HISTORIC AND DESIGN REVIEW COMMISSION

HDRC CASE NO: 2024-122
ADDRESS: 221 LOSOYA ST
LEGAL DESCRIPTION: NCB 914 LOT W IRR 90 OF A5 & W IRR 100 FT OF A4 PASEO DEL RIO CONDO **MASTER FILE AND COMMON ELEMENTS***
ZONING: D, H, RIO-3
CITY COUNCIL DIST.: 1
DISTRICT: Alamo Plaza Historic District
APPLICANT: Kyle Tostenson/kyle tostenson architects
OWNER: Jessica Elliot-Middleton/PASEO DEL RIO CONDOMINIUM
TYPE OF WORK: Fifth level balcony installation, fifth level window replacement, fenestration modifications at the fifth level
APPLICATION RECEIVED: March 01, 2024
60-DAY REVIEW: April 30, 2024
CASE MANAGER: Edward Hall
REQUEST:

Penthouse Condo Renovations @ Losoya Street Condos

PROPOSED FLOOR PLAN

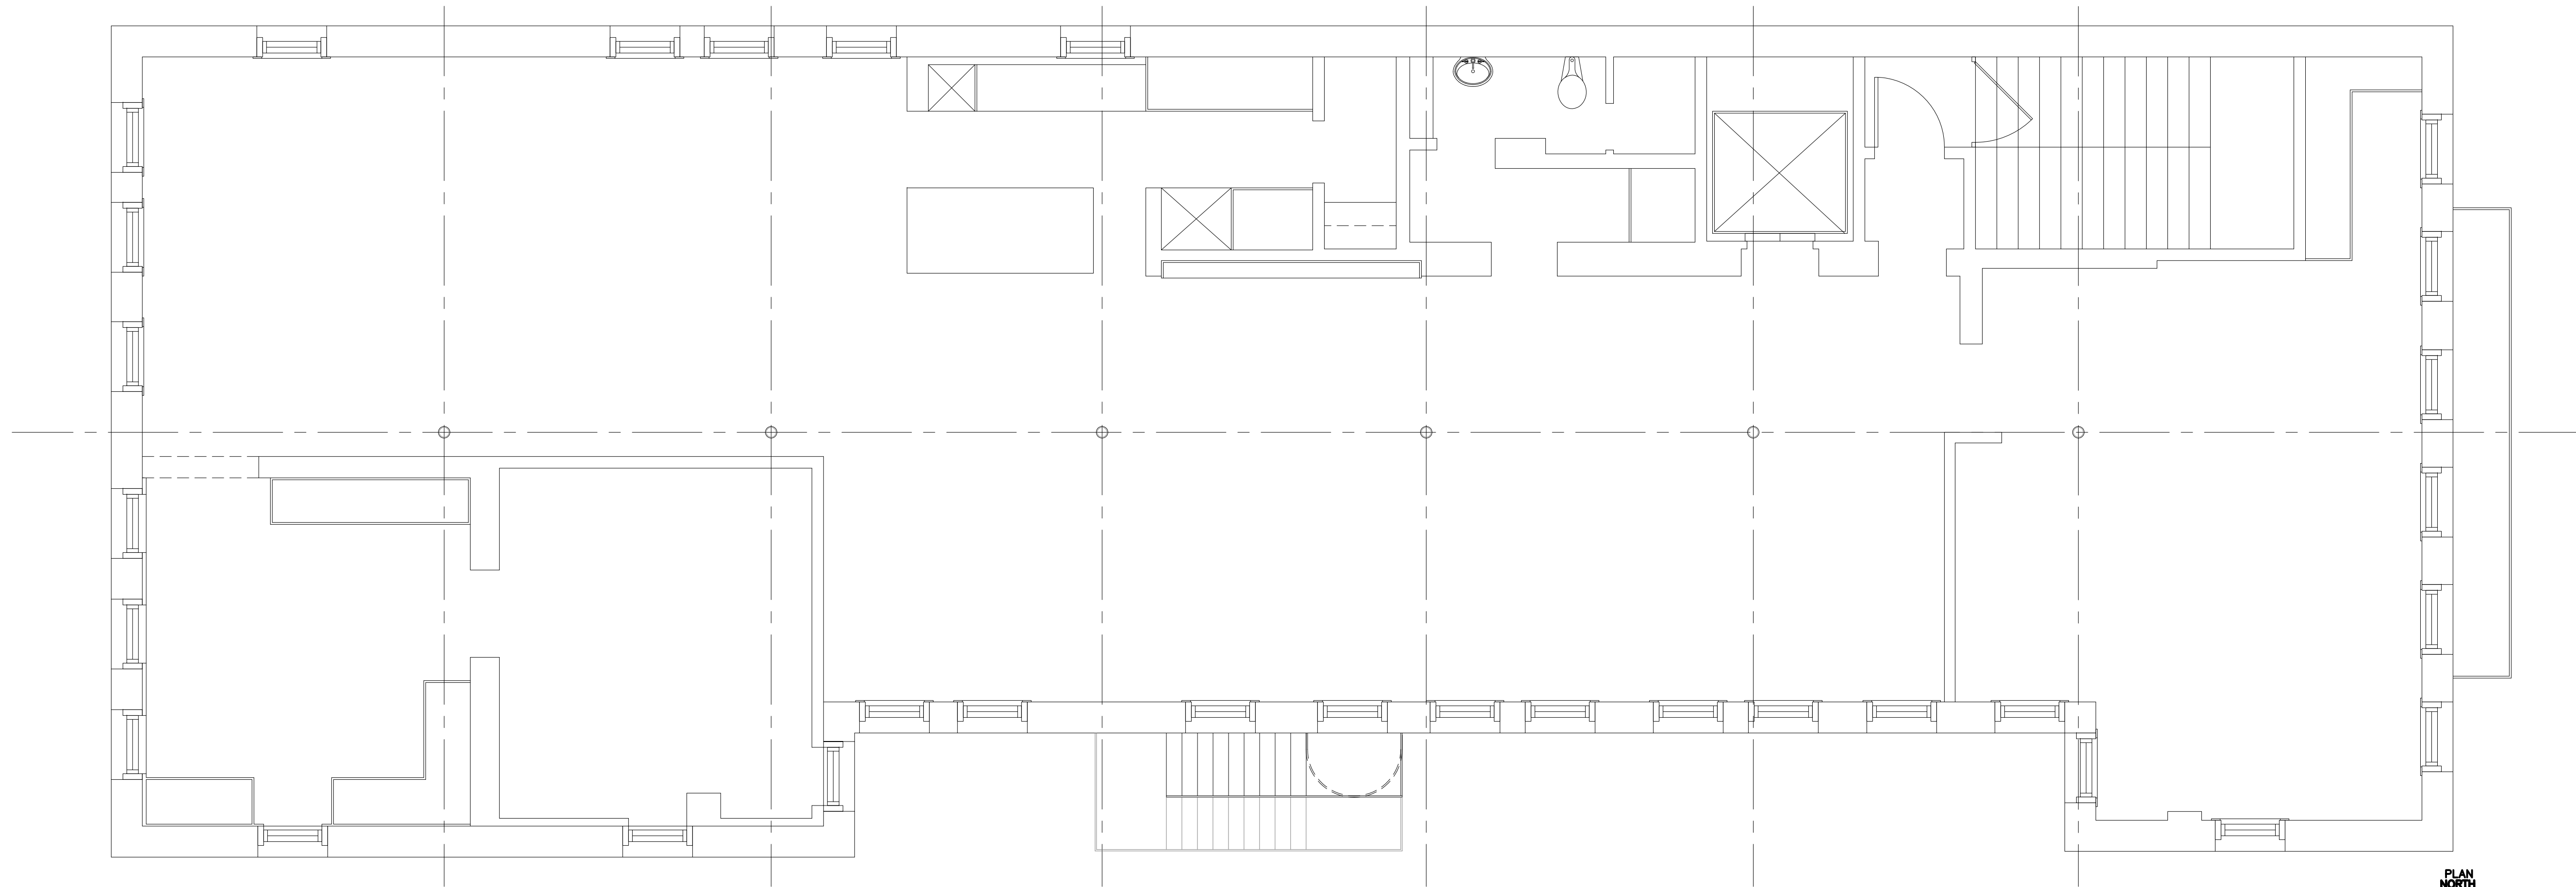
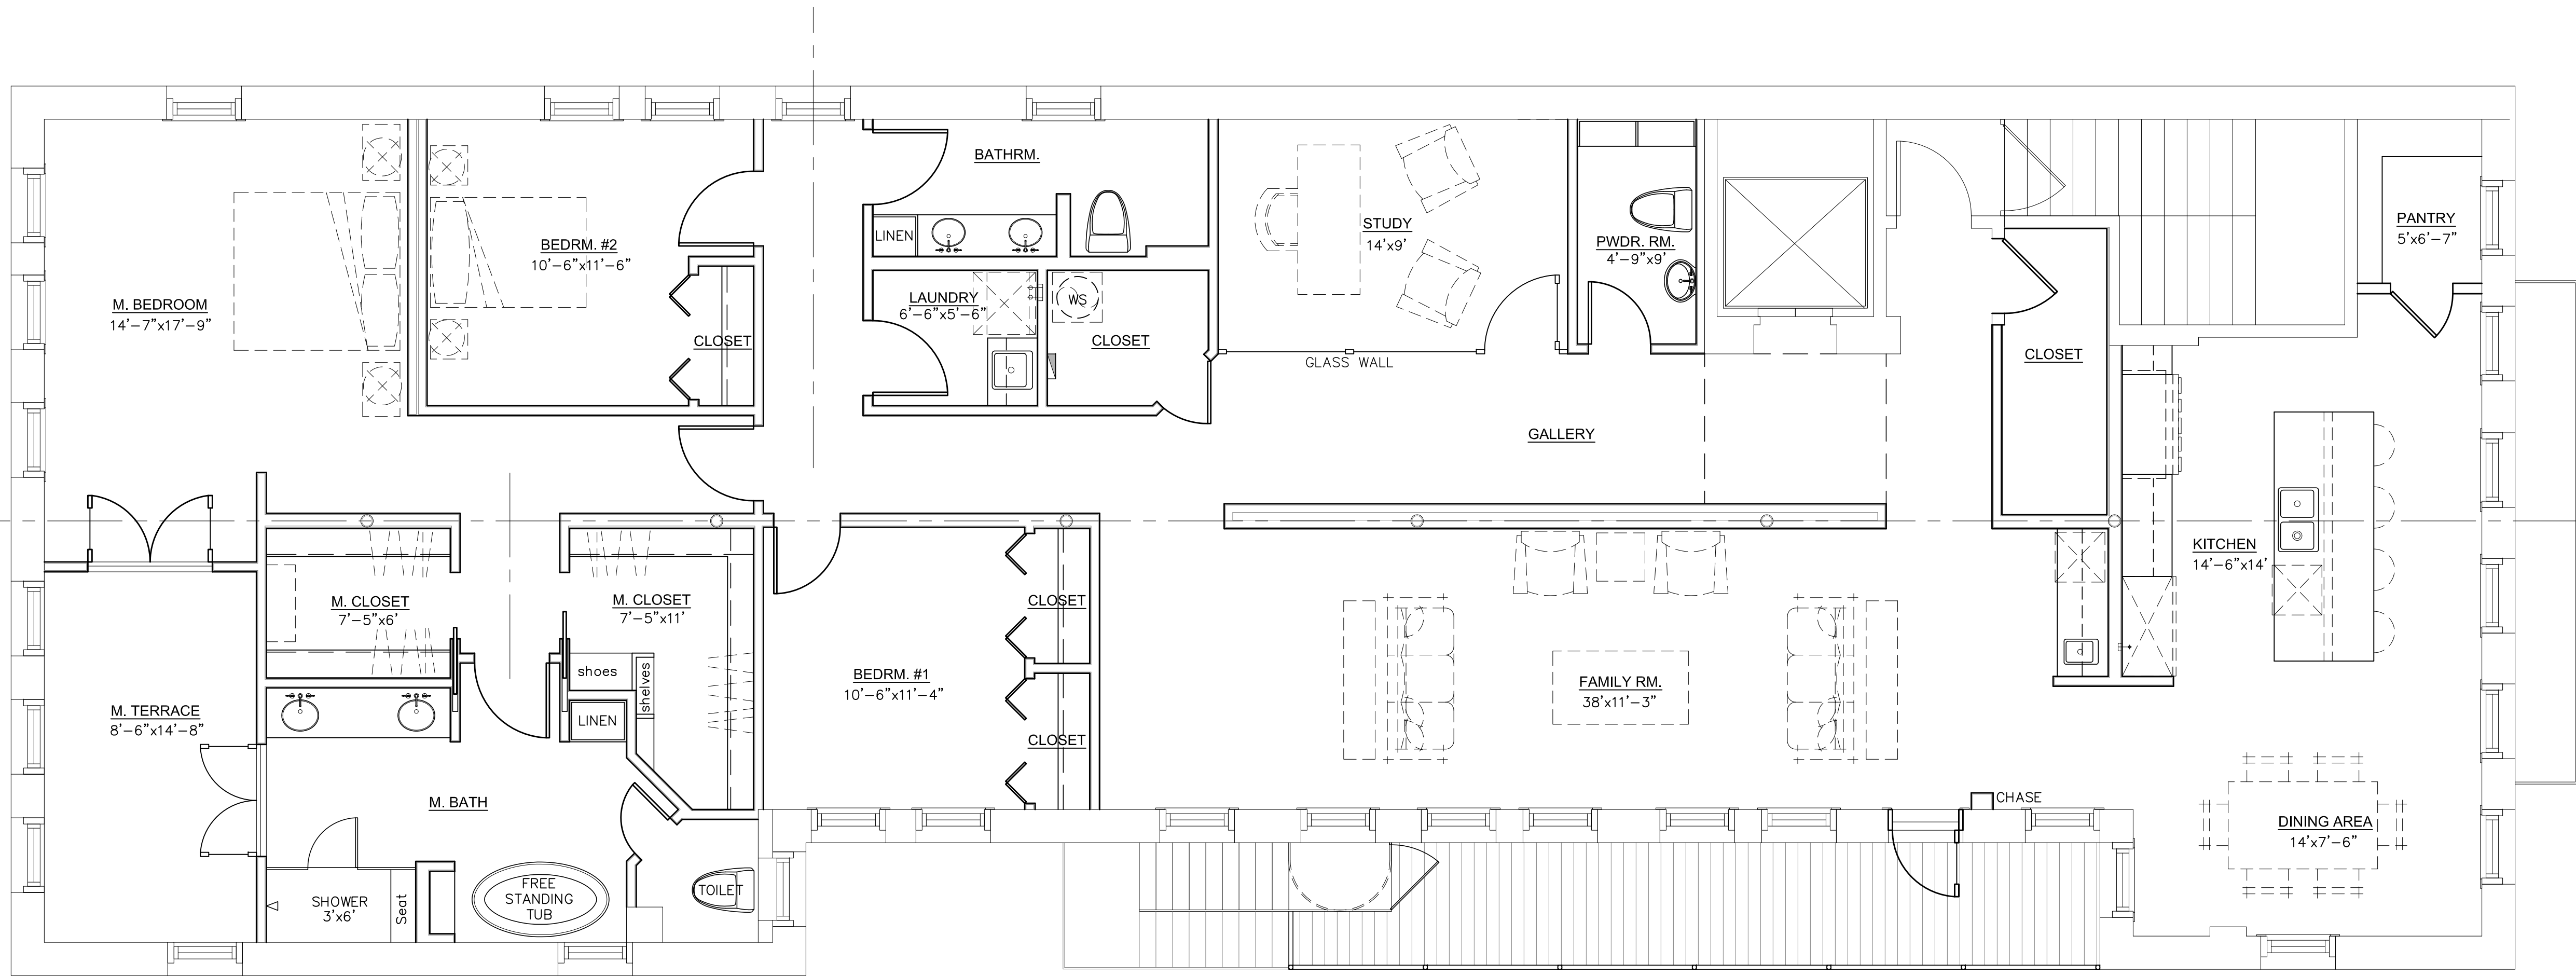
- c. WINDOW SASH REMOVAL – The applicant has proposed to remove four (4) existing, non-original windows to create an open air terrace at the rear of the structure. Three windows are on the west (rear) façade and one is on the south façade. The original window trim will be repaired and will remain in place. The opening size will not change. Generally, staff finds this proposal to be reversible and appropriate.

- d. WINDOW OPENING RESTORATION – The applicant has proposed to open (4) previously enclosed windows on the north façade. Staff finds this proposal to be appropriate; however, staff finds that all window elements, including trim and installation depth should match the original.

- e. BALCONY CONSTRUCTION – The applicant has proposed to construct a balcony within a recessed on the south façade. To facilitate access to the balcony, the applicant has proposed to modify one (1) original window opening to a door opening. Generally, staff finds this request to be appropriate and consistent with the Guidelines for Additions as it is not on a primary façade and is proposed on a recessed façade plane. Staff finds that all elements of the proposed balcony should be recessed as to not extend out past the primary façade plane on the south façade. Additionally, staff finds that an architecturally appropriate door should be installed to provide access to this balcony.

- i. That the profile of all new windows match the original windows (found on lower floors) in profile and installation depth, as noted in finding b.
- ii. That the openings at the proposed open air terrace maintain their original wood trim and openings size, as noted in finding c.
- iii. That the previously enclosed openings feature window trim and window installation depths that match the original, as noted in finding d.
- iv. That all elements of the proposed balcony be recessed as to not extend out past the primary façade plane on the south façade and that an architecturally appropriate door should be installed, as noted in finding e. Construction documents of the proposed balcony are to be submitted for review and approval when returning to the Commission for final approval.

REPLACEMENT WINDOW & DOOR TYPES 03
SCALE: 1/4" = 1'-0"

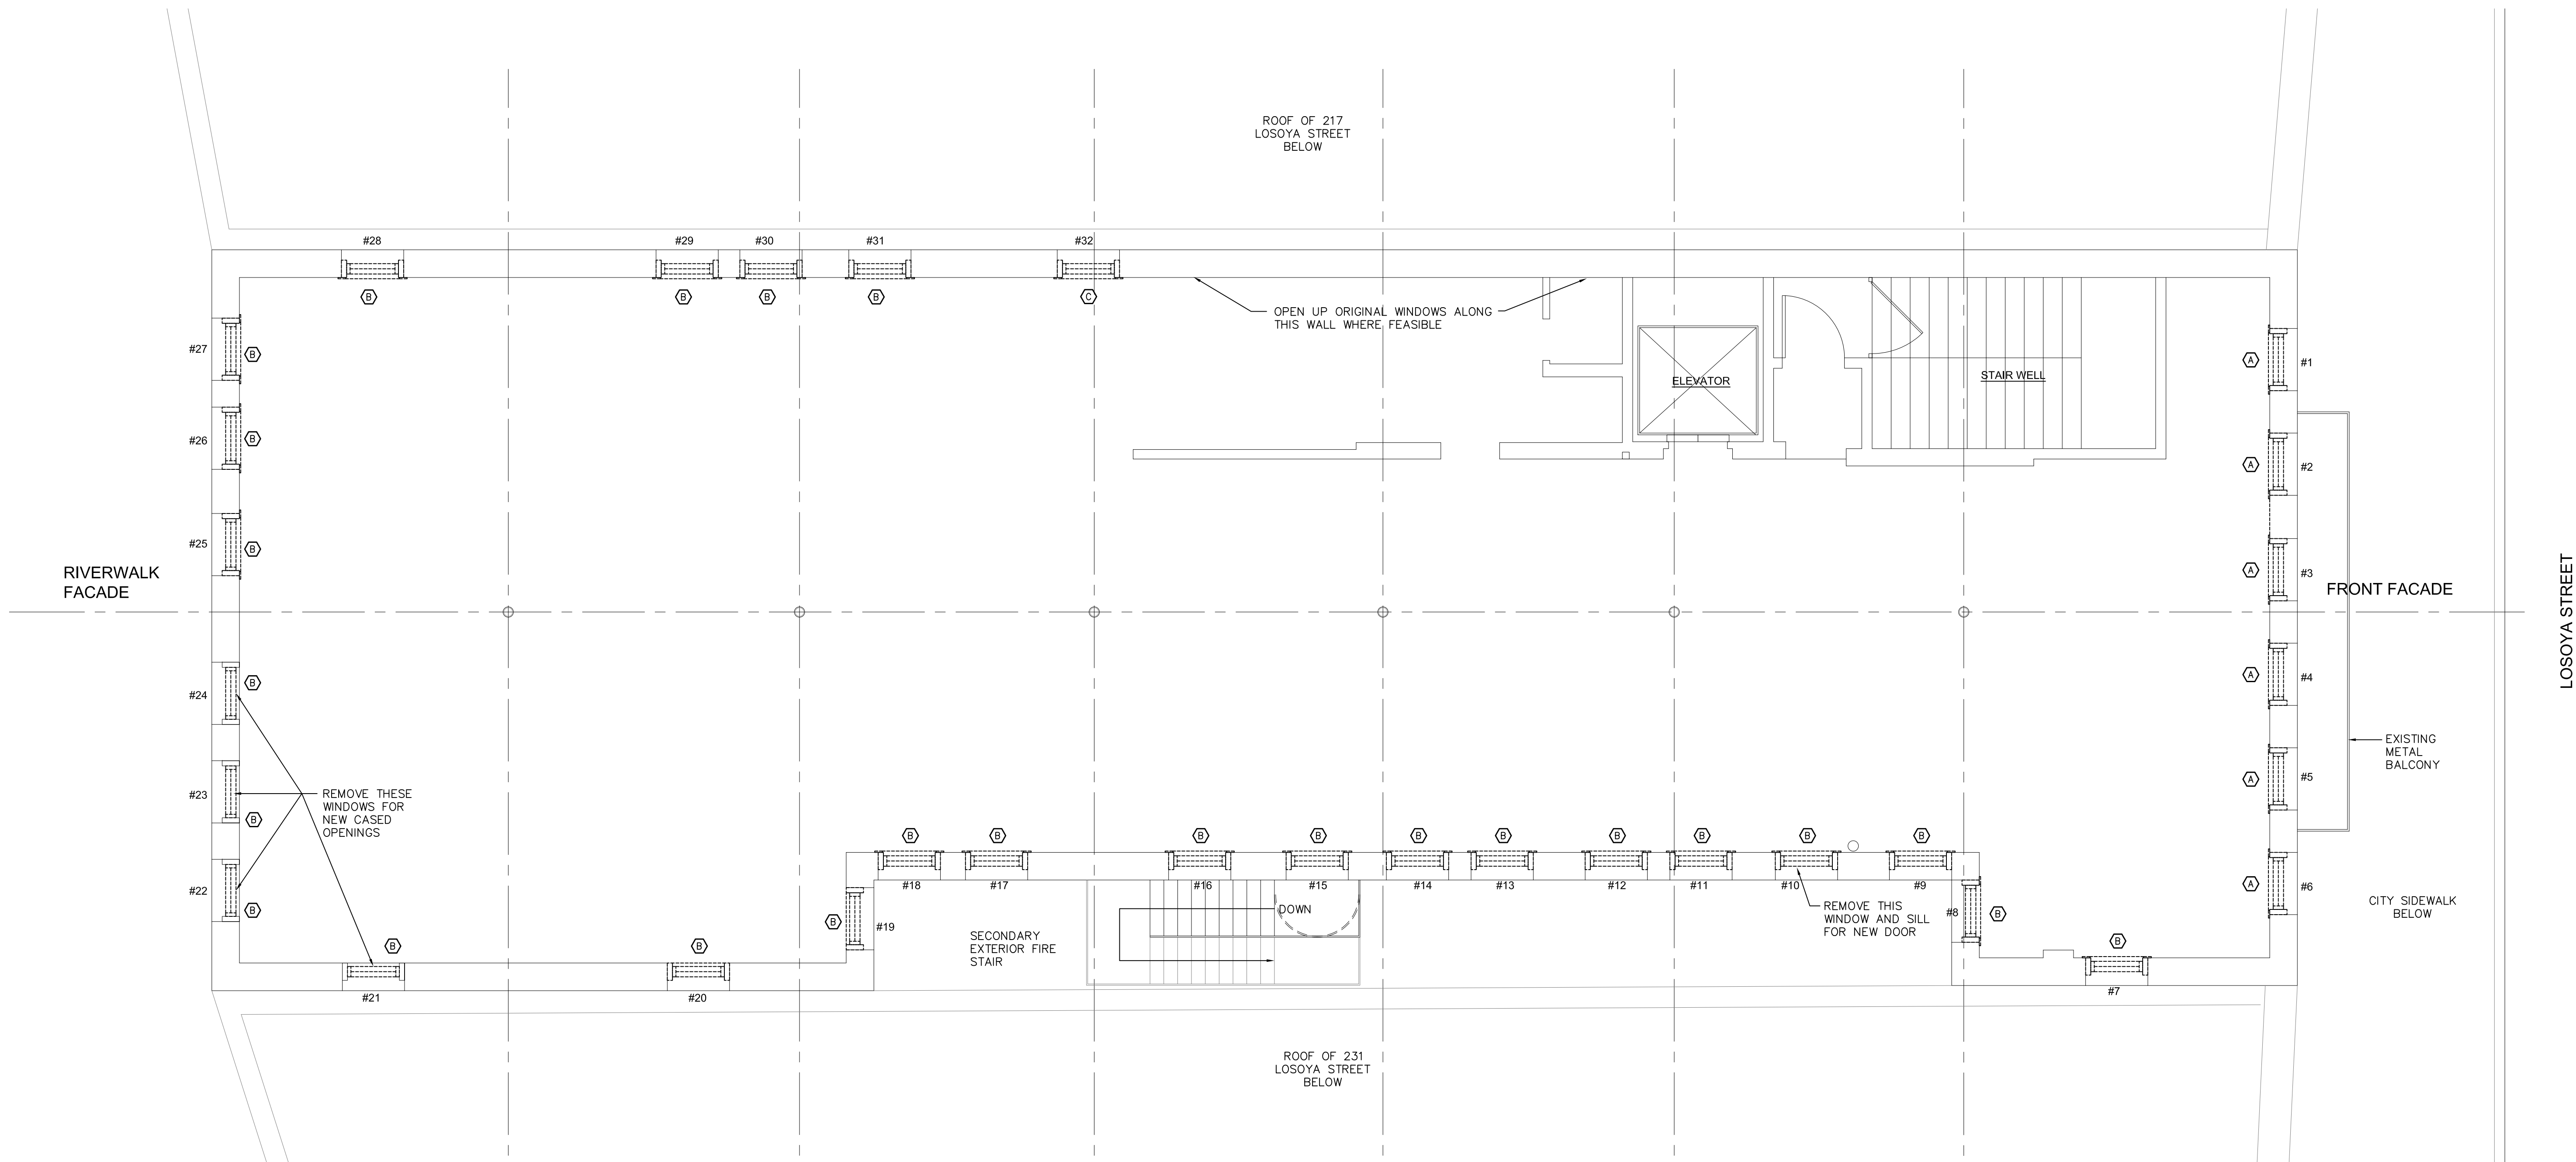
- b. WINDOW REPLACEMENT – The applicant has proposed to replace all of the existing, wood windows at the fifth level with new wood windows. Staff performed a site visit on March 25, 2025, and found all of the existing wood windows to be non-original and in various states of disrepair. Staff finds the proposal to replace the existing wood windows with one over one wood windows to be appropriate. Staff finds that the profile of the proposed replacement windows should match the original windows found on lower floors.
